OCONEE NUCLEAR STATION

TECHNICAL SPECIFICATIONS

TECHNICAL JUSTIFICATION

Technical Specification Change:

FIGURE 1 - LP/LPSW SYSTEMS

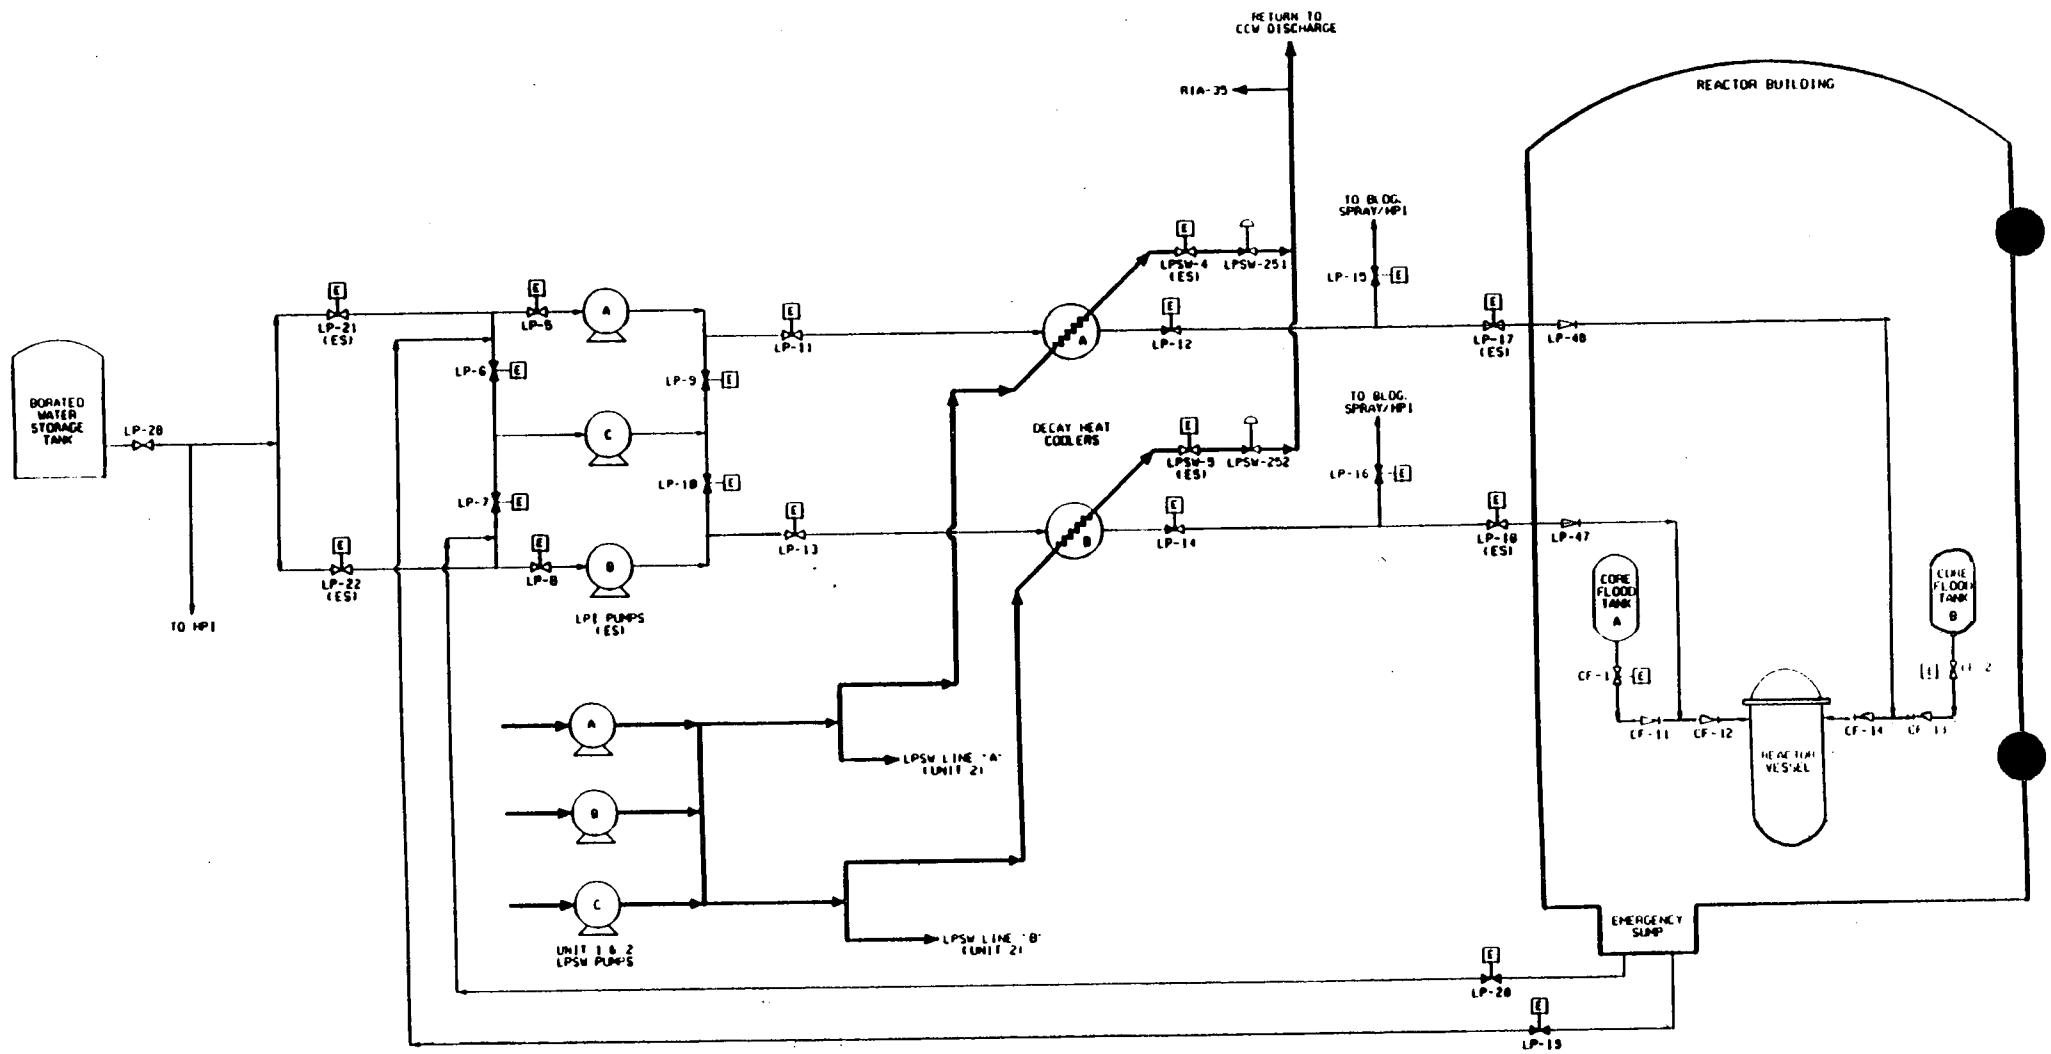
With the existing design, Engineered Safeguards (ES) channels 3 and 4 would actuate at either 550 psig Reactor Coolant System (RCS) pressure or 3 psig Reactor Building (RB) pressure. Actuation of ES channels 3 and 4 would automatically open valves LPSW-4 and LPSW-5 on the affected Oconee unit to admit LPSW cooling water flow to the Low LPI coolers. As shown in Figure 1, LPSW-4 is an isolation valve on the LPSW outlet from the A LPI cooler, and LPSW-5 is the isolation valve on the LPSW outlet from the B LPI cooler. This actuation would occur within several seconds following a large break LOCA. Initially, the LPI System would operate in the injection mode taking its suction from the borated water storage tank (BWST). Upon reaching a specified minimum level in the BWST, operators would establish the recirculation mode by realigning the suction

To resolve the NPSH issues, Duke proposes to remove the ES signal that automatically opens valves LPSW-4 and LPSW-5. After establishing RBES recirculation mode, operators would isolate flow to the LPSW non-essential header and throttle open LPSW-4 and LPSW-5 from the control room. This will maintain LPSW flow demand low enough so that the NPSHa remains greater than NPSHr.

Removing the ES signal from valves LPSW-4 and LPSW-5 requires a change to Technical Specification 4.5.1.1.2 (a) (2). This Technical Specification requires a functional verification of the ES function of valves LPSW-4 and LPSW-5 on a refueling outage frequency. Under the proposed change, the reference to ES will be changed so that it applies to the LPSW pumps but not to LPSW-4 and LPSW-5. The capability of the operators to open LPSW-4 and LPSW-5 from the control room will be verified under this revised surveillance requirement.

FIGURE 2 - NON-ESSENTIAL LPSW LOADS

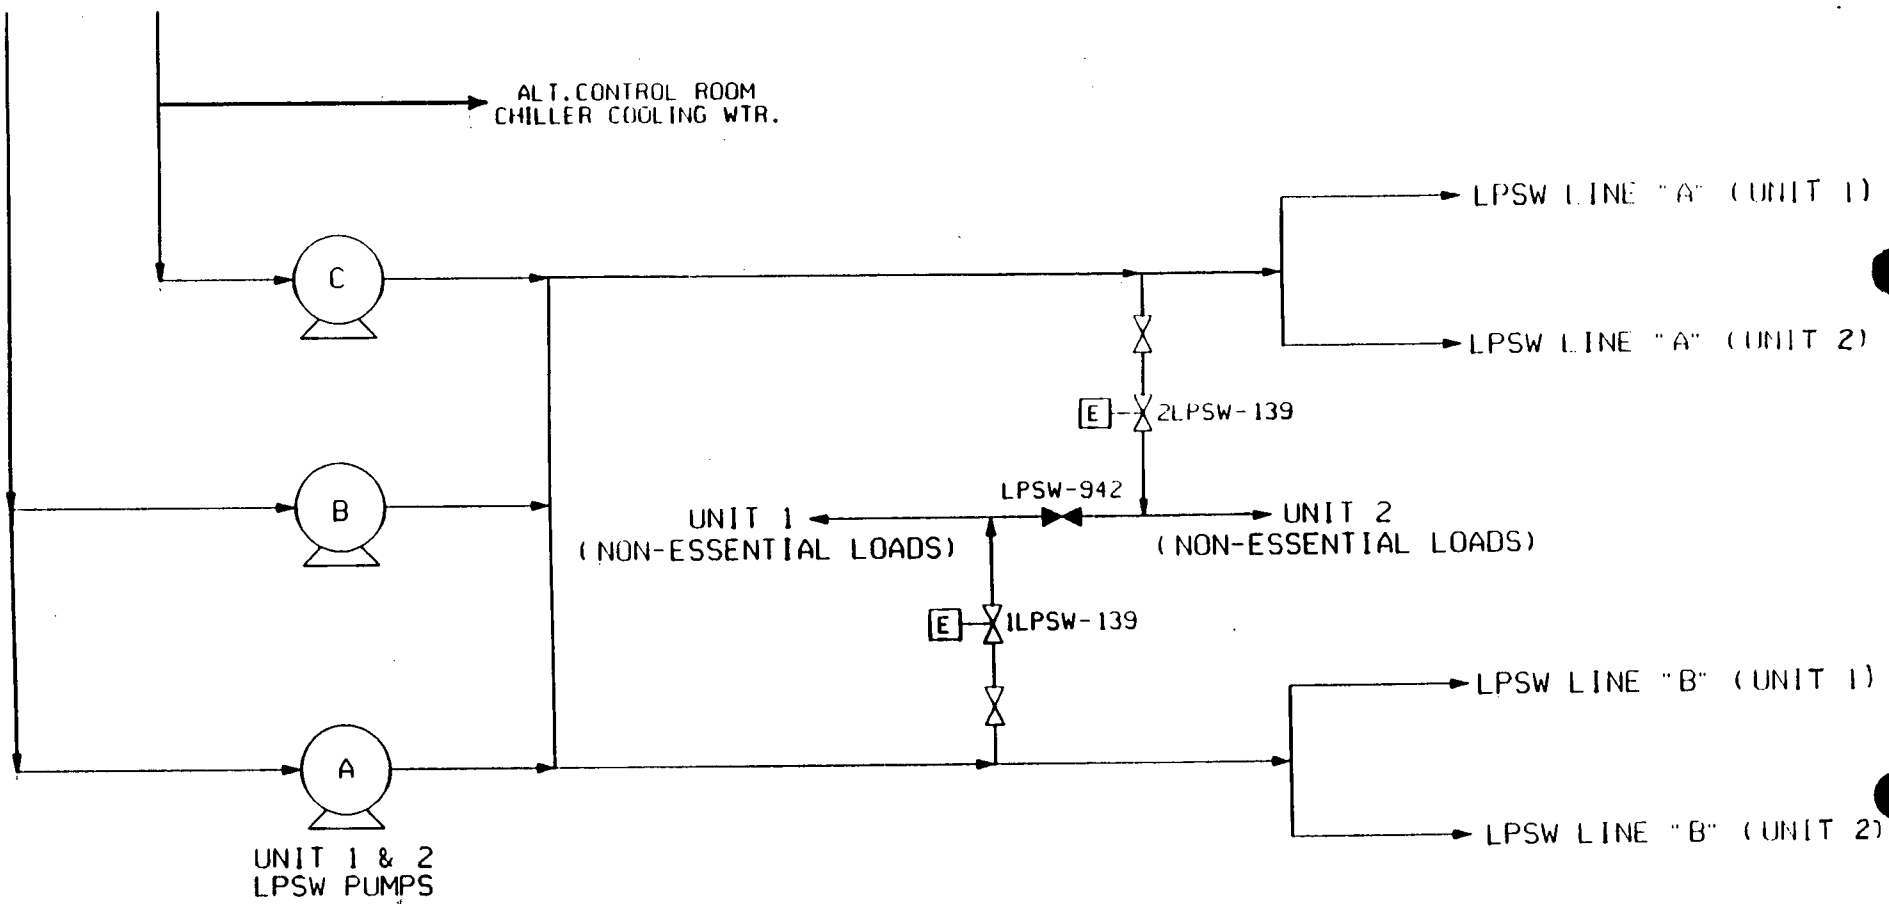
A review of the operator burden for opening LPSW-4 and LPSW-5 was performed. During the first 30 minutes after a LOCA/LOOP, actions performed by the operators would not be affected by the proposed change. During this period, the operators must verify proper operation of all ES equipment. Also, operators monitor BWST level and begin switchover to RBES recirculation at the appropriate level in the BWST. After completion of the switchover to RBES recirculation, operators would be required to isolate the LPSW non-essential header. Isolation of the non-essential header will require closing one valve, either 1LPSW-139 (Unit 1), 2LPSW-139 (Unit 2), or 3LPSW-45 (Unit 3). After completion of the ECCW upgrade project, controls for these valves will be located in the control room for their respective unit. In addition, valve 3LPSW-45 will be renumbered as 3LPSW-139 to be consistent with the other units' valve numbers. See Figure 2 for the planned configuration for the Unit 1 and 2 LPSW non-essential header.

After isolating the LPSW non-essential header, operators will throttle open LPSW-4 and LPSW-5. Controls for these valves are located in the control room, and flow indication is located with the valve controls. Normally, LPSW flow to the LPI coolers is throttled using air-operated valves. During a design basis accident involving a loss of instrument air, the air-operated valves fail open to their travel stops. Therefore, motor-operated valves LPSW-4 and LPSW-5 are used to throttle LPSW flow to the LPI coolers under these conditions. The existing design basis for Oconee takes credit for throttling LPSW-4 and LPSW-5 from the full open position to an intermediate position within 30 minutes after a LOCA/LOOP to reduce NPSHr.
